APPLICATION FOR PERMISSION UNDER SECTION 16 TOWN PLANNING APPLICATION FOR THE PROPOSED TEMPORARY WAREHOUSE (EXCLUDING DANGEROUS GOODS GODOWN) AND ASSOCIATED FILLING OF LAND FOR A PERIOD OF 3 YEARS IN "AGRICULTURE" ZONE IN LOT NOS. 956 AND 959 RP IN D.D. 107, FUNG KAT HEUNG ROAD, KAM TIN, YUEN LONG, NEW TERRITORIES

Town Planning Application No. A/YL-KTN/1283

Submission of Further Information (1)

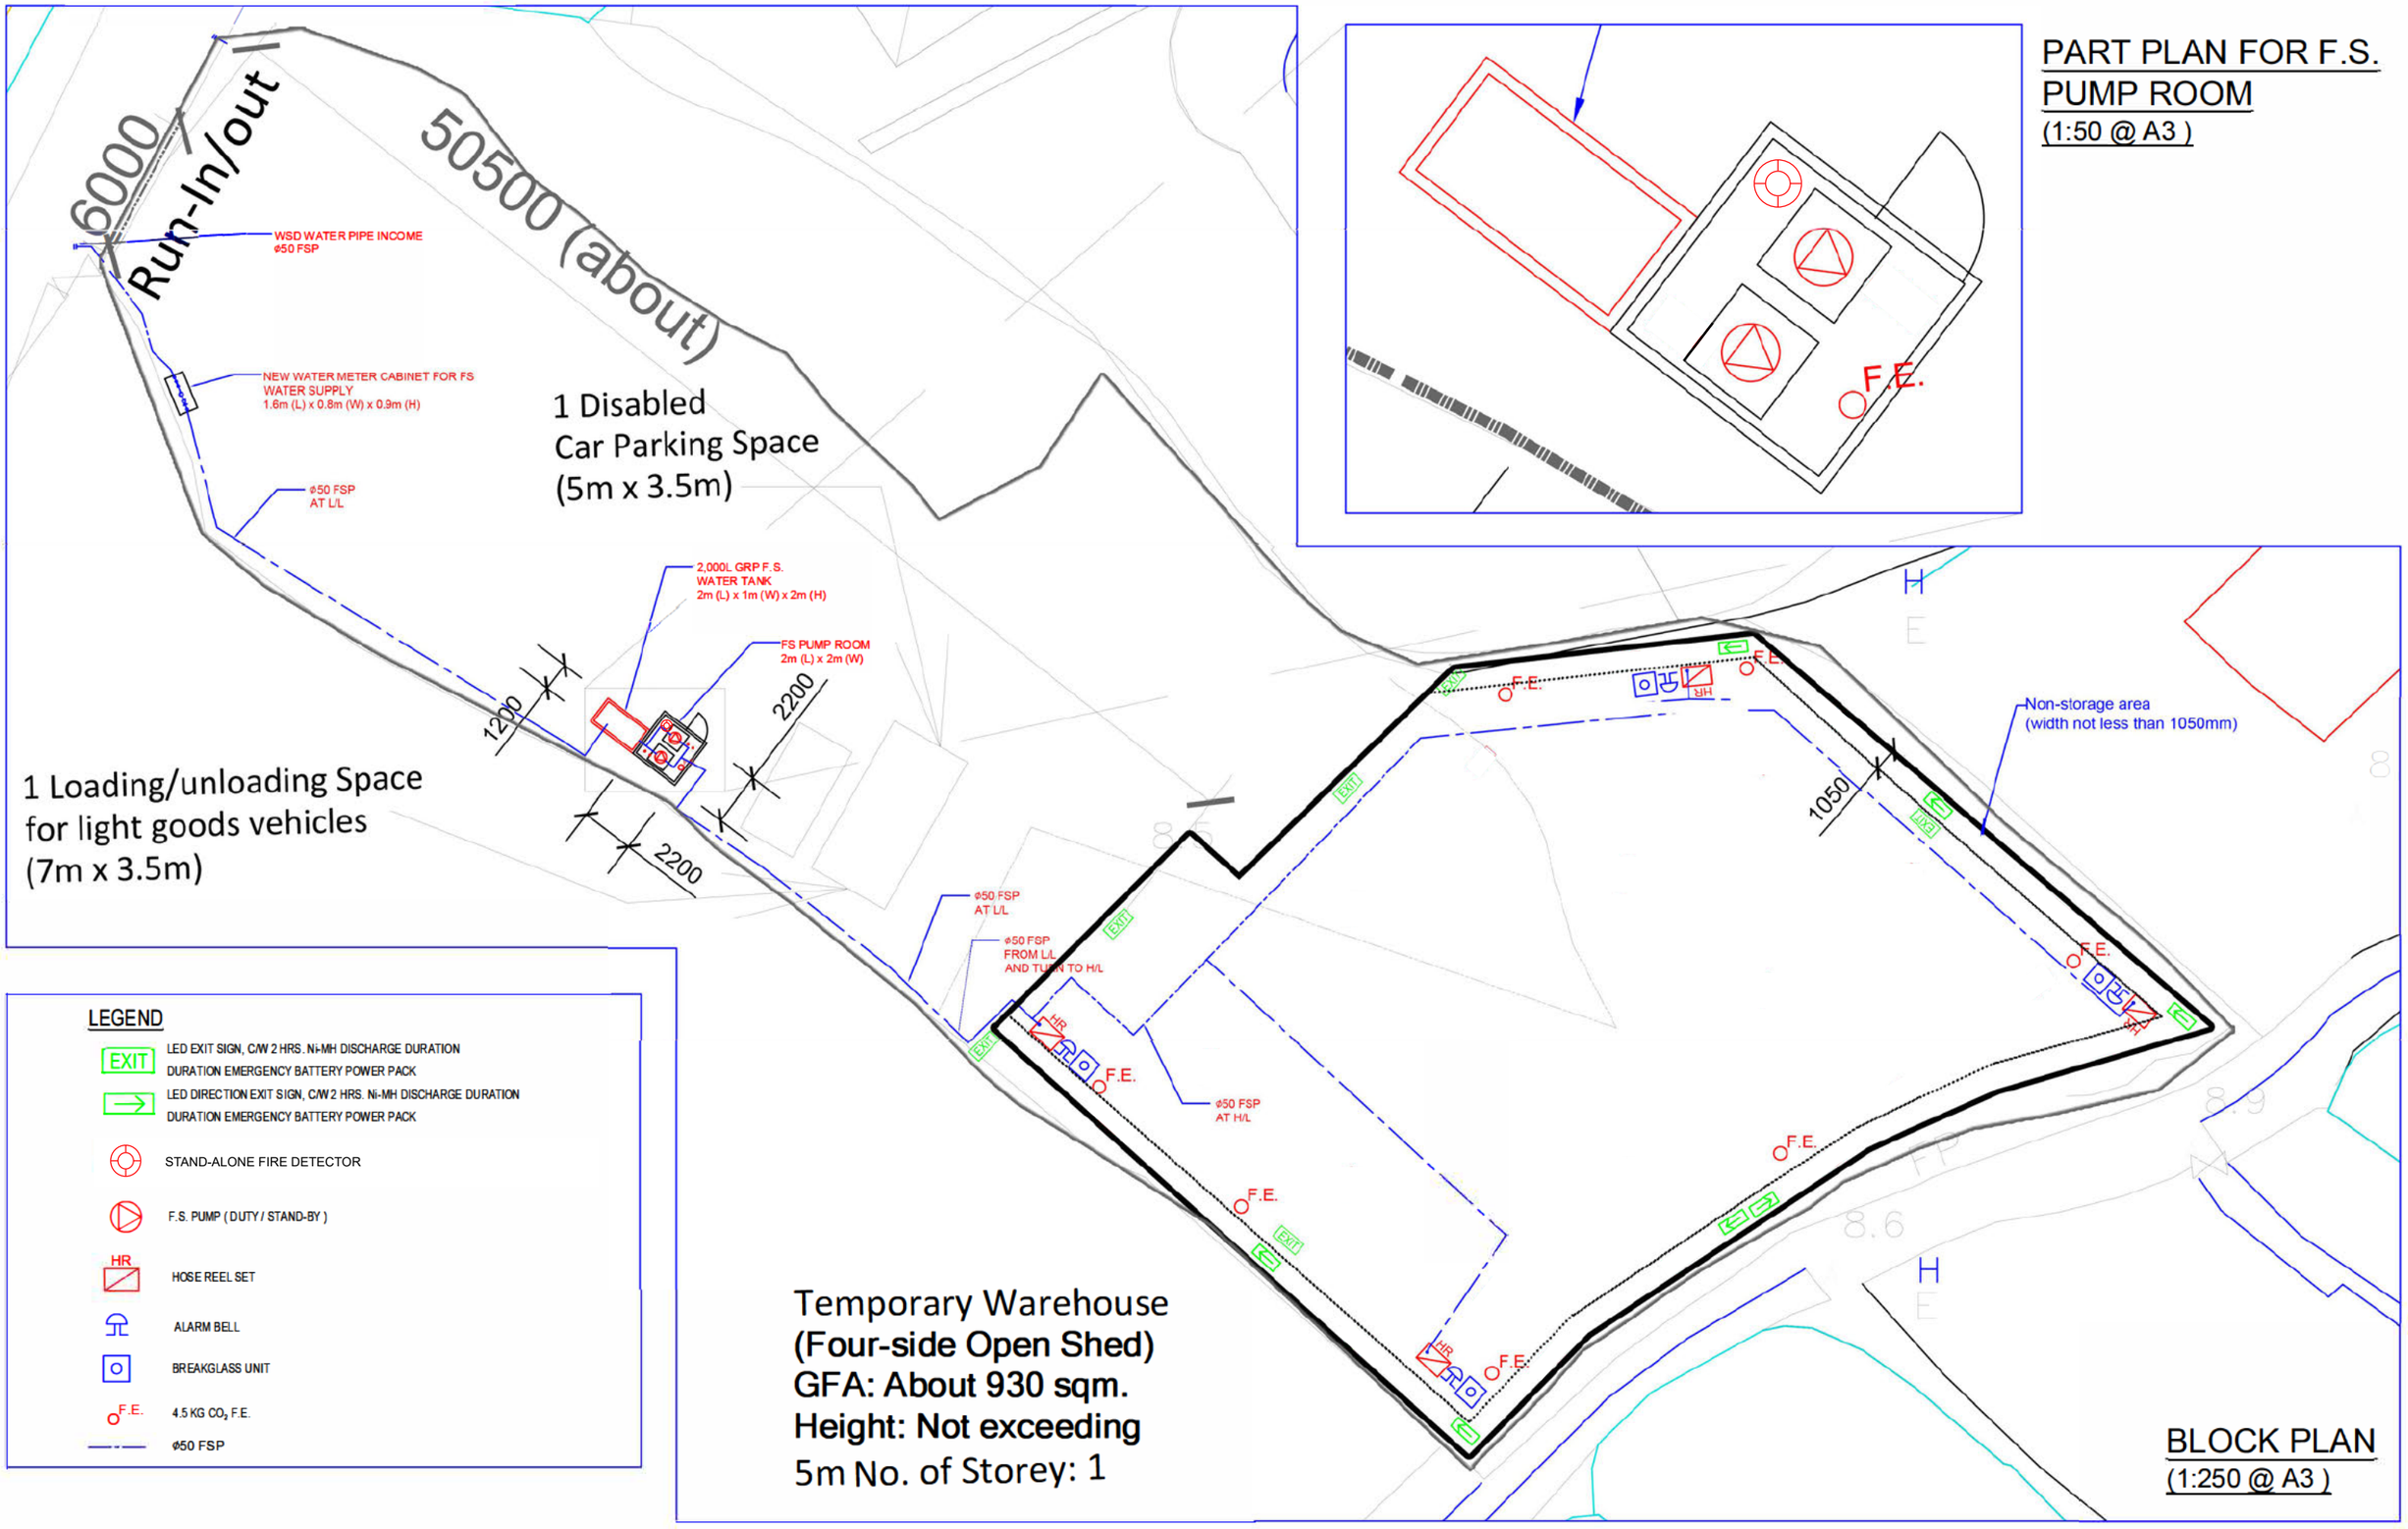
Departmental Comments (Email from Planning Department dated 22.09.2026)	
Departmental Comments	Response
FSD	
i. For enclosed structure with gross floor area not exceeding 230 m^2, i.e. FS Pump Room, portable fire extinguisher and stand-alone fire detector shall be provided;	Revised. Please refer to **Appendix 1 – Revised FSI Proposal**.
ii. In relation to item (i) above, if two or more stand-alone fire detectors are installed in an enclosed structure, all detectors shall be interconnected (either wired or wirelessly) such that when one of the detectors is triggered, all connected detectors shall sound an alarm simultaneously;	Noted.
iii. Stand-alone fire detectors shall be provided in accordance with the "Stand-alone Fire Detector General Guidelines on Purchase, Installation & Maintenance [Sep 2021]";	Noted. Please refer to **Appendix 1 – Revised FSI Proposal**.
Iv. Modified hose reel system, fire alarm system, emergency lighting and directional & exit signs are considered as self-upgrades and are not mandatory requirements of FSD;	Noted.

v. If the applicant self-initiates the provision of a modified hose reel system, the standard and specification shall be provided in accordance with the "Codes of Practice for Minimum Fire Service Installations and Equipment and Inspection, Testing and Maintenance of Installations and Equipment [September 2022 revision]"; and	Noted. The standard and specification of the modified hose reel system is in accordance with the "Codes of Practice for Minimum Fire Service Installations and Equipment and Inspection, Testing and Maintenance of Installations and Equipment [September 2022 revision]". Please refer to **Appendix 1 – Revised FSI Proposal**.
vi. For shed(s) open on 2 sides or more, only fire extinguishers shall be provided.	Noted.
